October 31, 2025  
Project No. 2402309

**Re: Peer Review Comments**  
**Maximum Predicted Water Table and Hydrogeological Assessment Report**  
**Proposed Class 'A' Pit Above Water (Watson Pit), Teeswater Concrete Ltd.**  
**311804 Highway 6, Mt. Forest**  
**Municipality of West Grey, Grey County**

## Appendix B

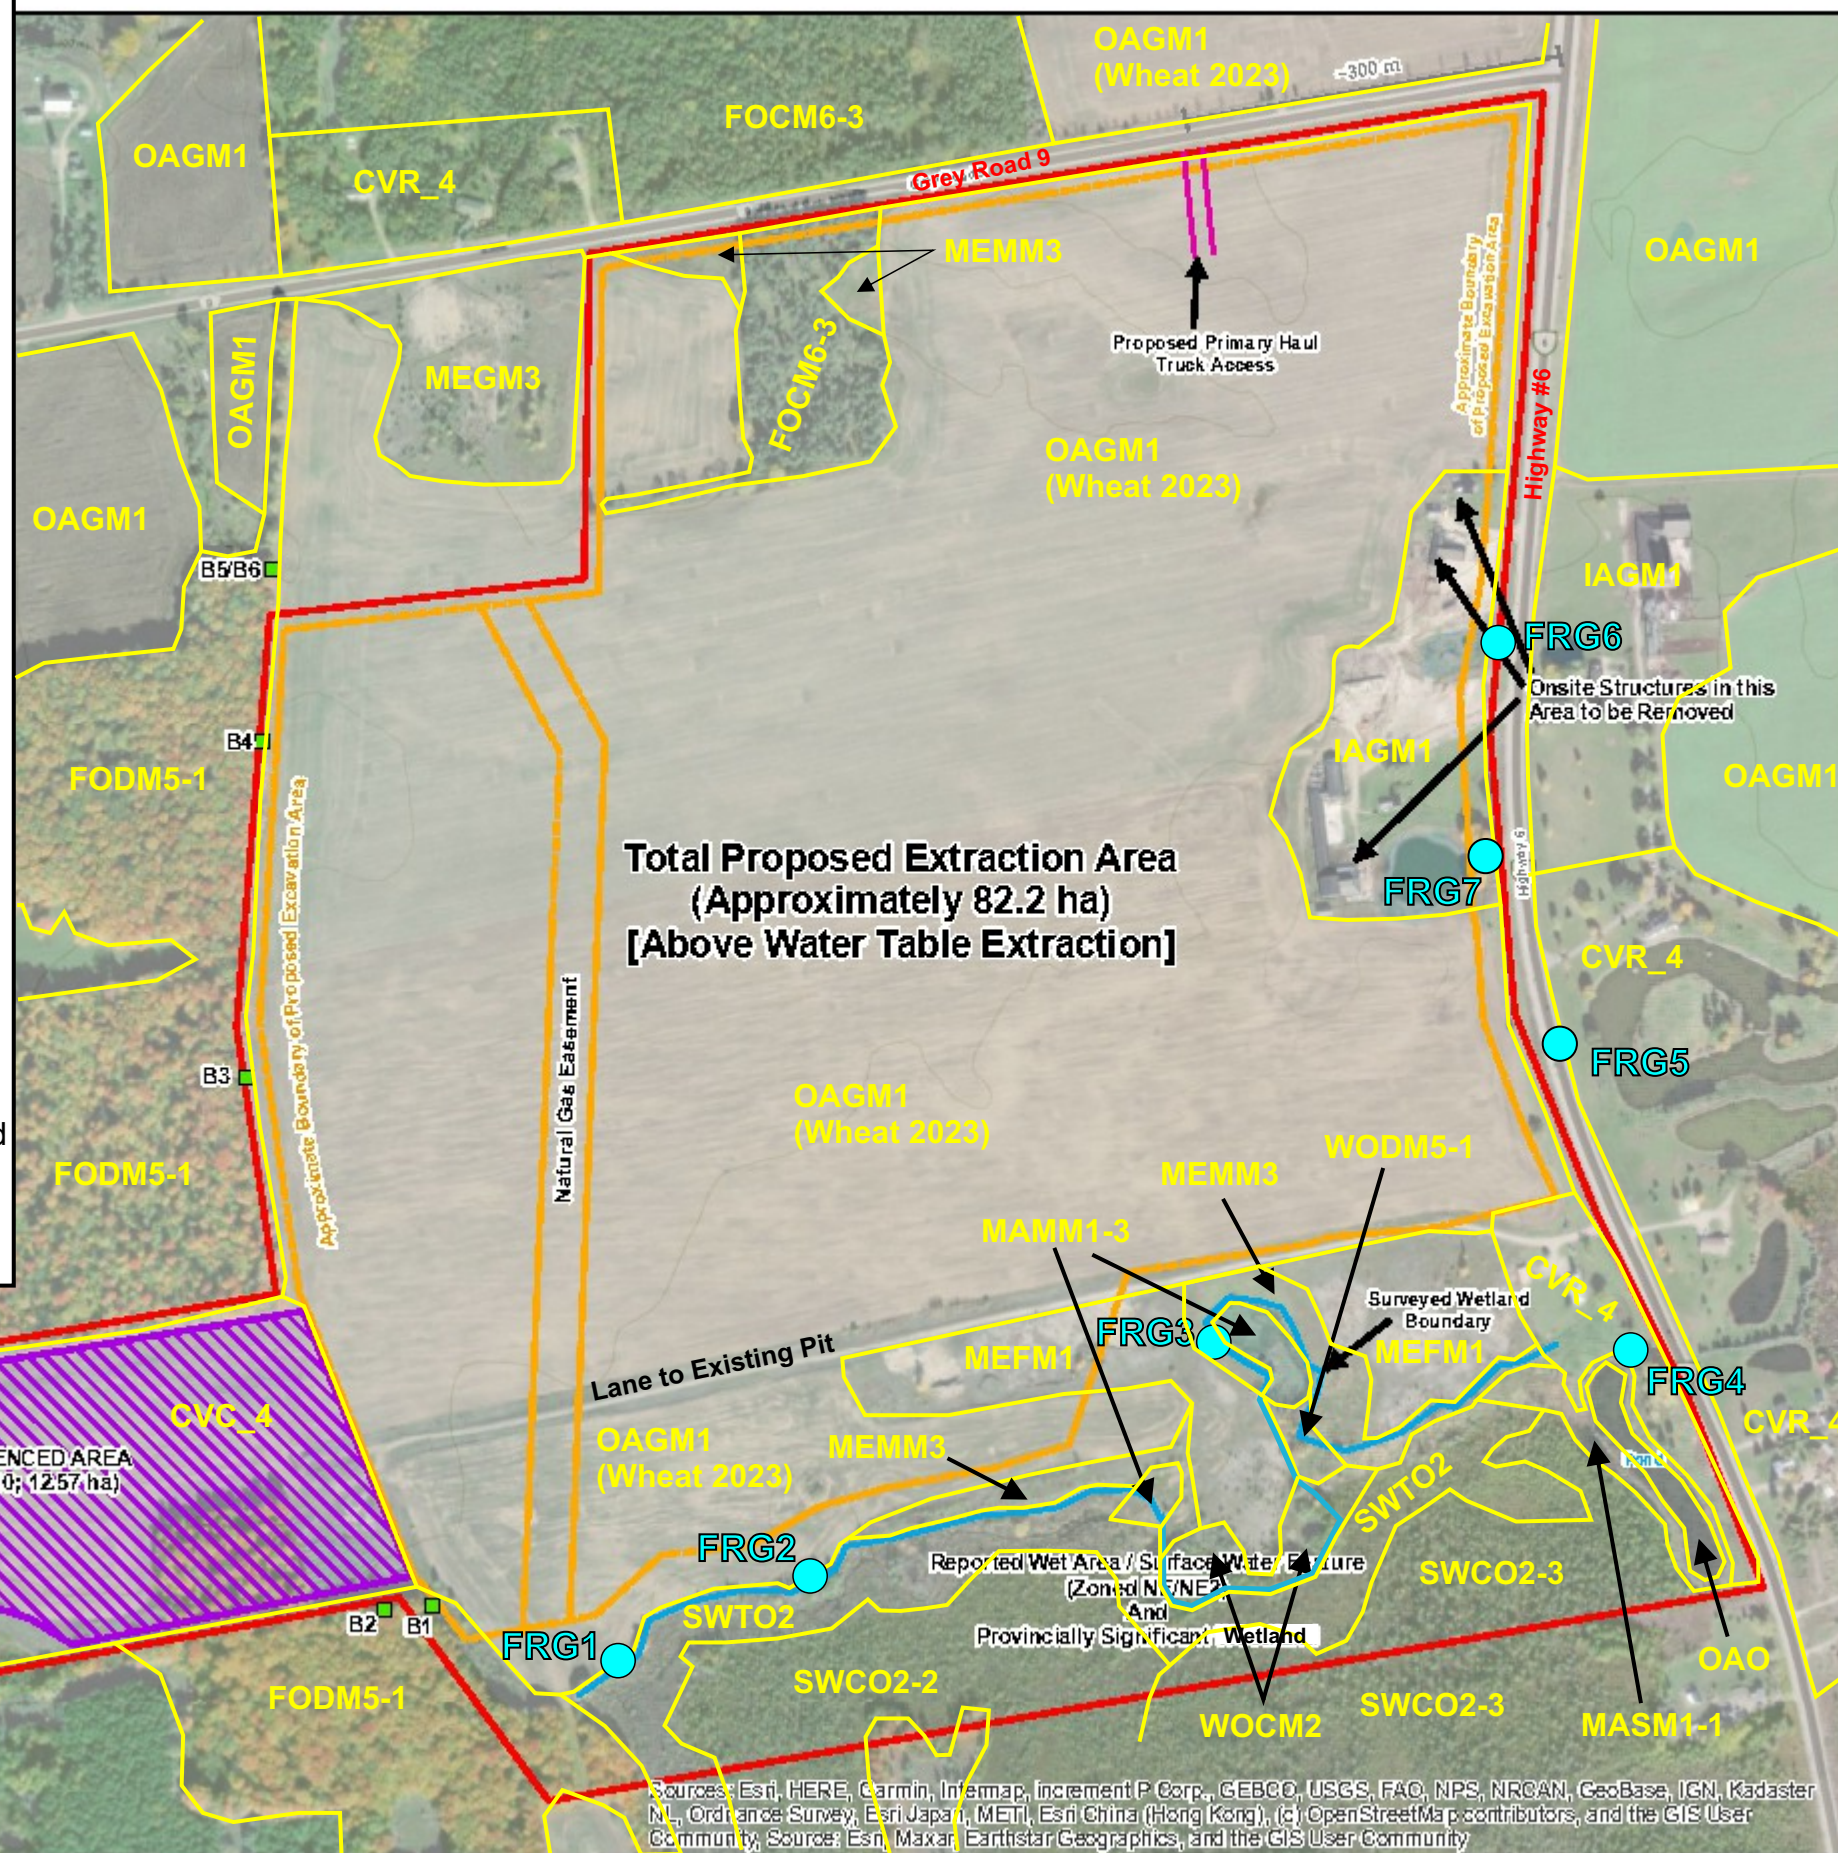
3. Table 2 in the report indicated that the groundwater elevations measured on March 22, 2023 were considered to be the annual maximum groundwater table elevation for the site. However, the water level data presented in Table 2 indicated that the groundwater levels measured in MW-1S, MW-4S and MW-5S on July 18, 2023 were approximately 0.5 m higher than the recorded water levels on March 22. Conversely, the recorded water level in MW-2 declined by 2.7 m over the same period. The recorded October 2023 water levels for MW-1S, MW-4S and MW-5S were also higher than the March 2023 levels. The data indicated that the annual high water table elevation identified in the report and shown on the site plans were not consistent with the conditions at the site. Additional data should be provided as necessary to adequately demonstrate the typical seasonal high water table for the site has been identified.

Groundwater levels have been monitored since 2023 and continue to be monitored at the pit property, with dataloggers being installed in the fall of 2025. The most recent water level data that has been obtained is enclosed with this letter. The results of the groundwater level monitoring noted that the highest water levels were observed in June of 2024 for all wells with the exception of MW2, MW3 and MW6s. These monitoring wells experienced their highest water levels in March of 2023.

To provide more certainty regarding maximum groundwater elevations, groundwater levels continue to be monitored at the pit property, with dataloggers being installed in the fall of 2025.

- POST -  
DEVELOPMENT  
DRAINAGE PLAN  
Figure No. 2

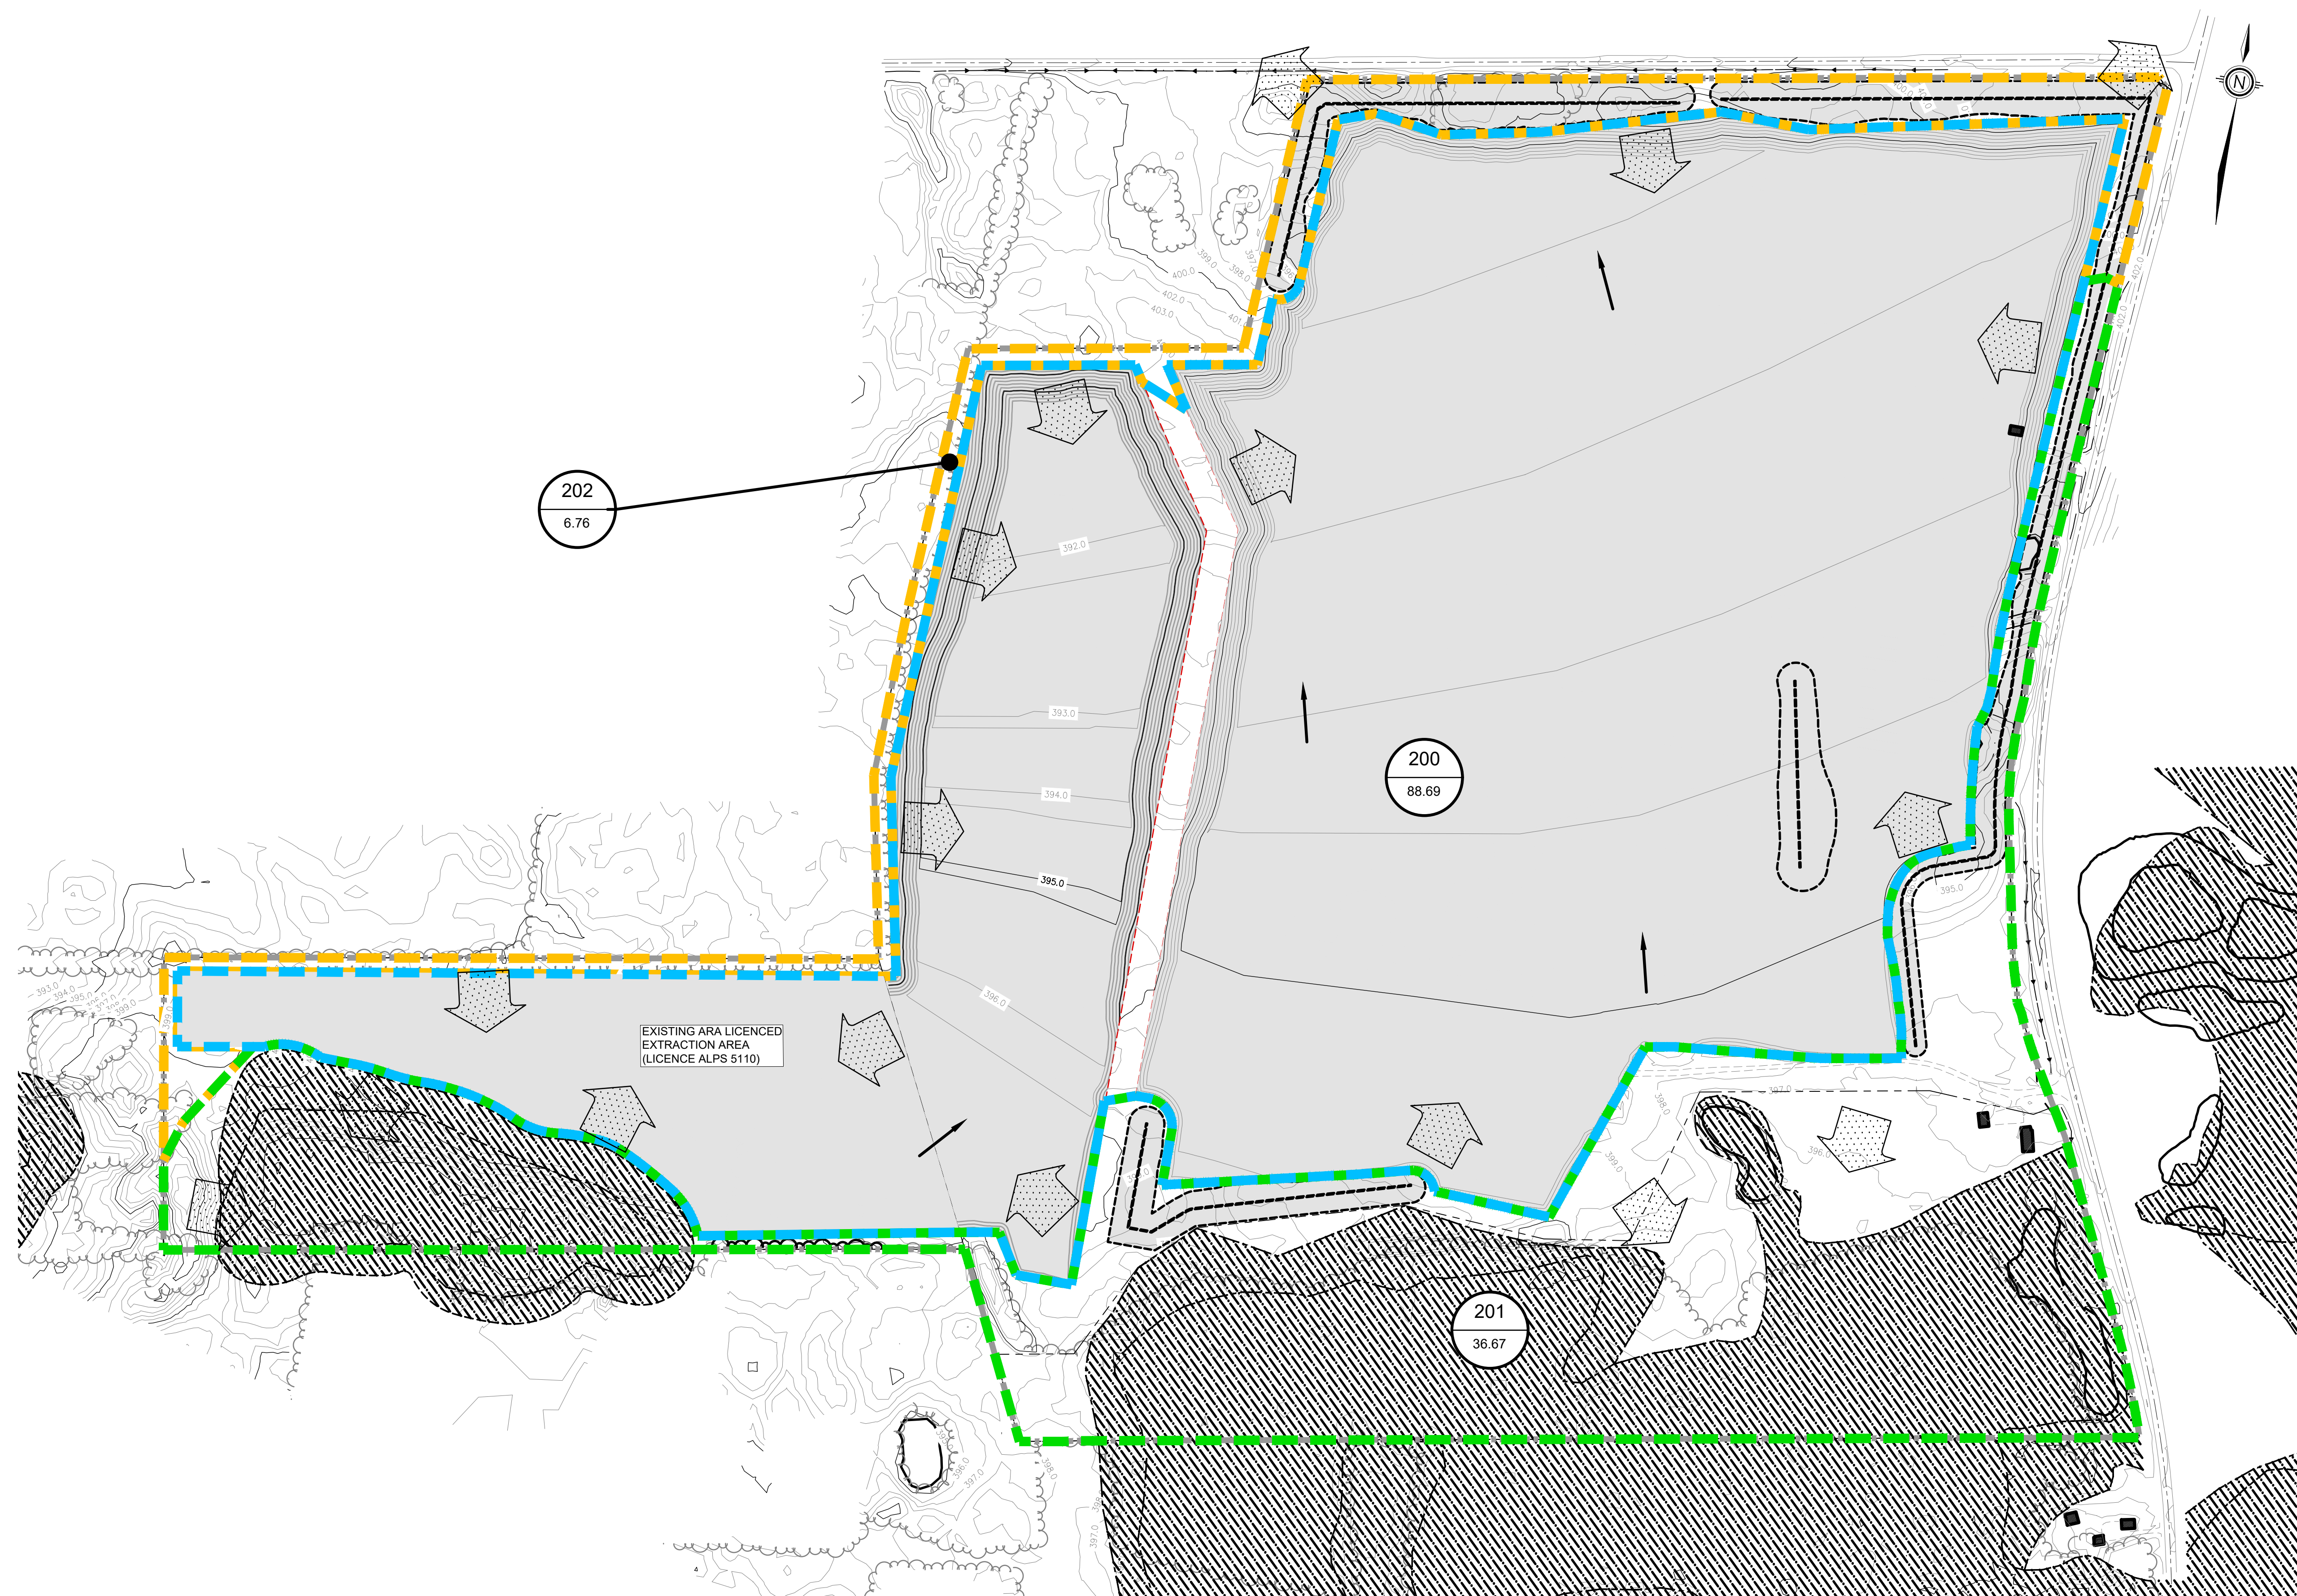
9. The report noted that since there are no proposed interactions with the water table or surface water features, the overall water budget, pre- to post-, is expected to remain unchanged and stated that equal infiltration to the subsurface will continue post-development. A water budget for the site was not presented. The main components of a water budget are precipitation, losses from evapotranspiration, runoff and infiltration. The progressive rehabilitation plan (Drawing 3) indicated that the completed pit floor will slope towards the north and be 9 m below the existing ground at the north limit of extraction. The notes on that plan indicated that the surface water drainage will be by percolation or evaporation. Under those conditions, the expected run off from the completed area of extraction would be zero. From the information provided in the report and site plans, it was not apparent that there is currently no runoff from that area. A reduction in the existing runoff would change the water budget and result in a corresponding increase in infiltration. GMBP should provide additional information to support the conclusion that the water budget for the site will not be changed by the proposed development. If there is a potential for a change in the water budget, then the associated implications should be evaluated. It is not apparent that increased infiltration would negatively affect the on-set wetland to the south, but there would be a potential for an increase in the elevation of the seasonal high water table on the site.

10. The report and site plan notes indicated that to maintain surface water flows to the same low-lying locations, the restored grades shall be sloped to maintain similar pre- and post- development catchment areas. The pre-development catchment areas were not identified, and it was not apparent how similar post-development catchment area would be maintained for the proposed area of extraction. Additional information should be provided to indicated how that recommendation would be implemented.

A technical memo has been prepared (enclosed) outlining the impact to infiltration from the pit property.

A technical memo has been prepared (enclosed) outlining the impact to infiltration from the pit property.

In the post-development condition, the proposed pit areas were assumed to act as infiltration pits which will infiltrate all surplus precipitation without any runoff to the nearby features. The existing farmhouse area is replaced with ‘lawn’ land use. All other parameters remained consistent in the post-development condition. Please see the documents attached to the back of this memo for the pre-development and post-development figures and detailed calculations.

According to Figure No. 3 from the Hydrogeological Study, dated November 2023, the shallow groundwater is flowing in a general northerly direction. The additional infiltration from the extracted pits in the post-development condition are added to the total surplus of volume contributing to the north. With this approach, the annual average surplus volume, consisting of both surface and groundwater flow, draining north under both pre-development and post-development conditions, were calculated and compared. The results are shown in **Table 1** below.
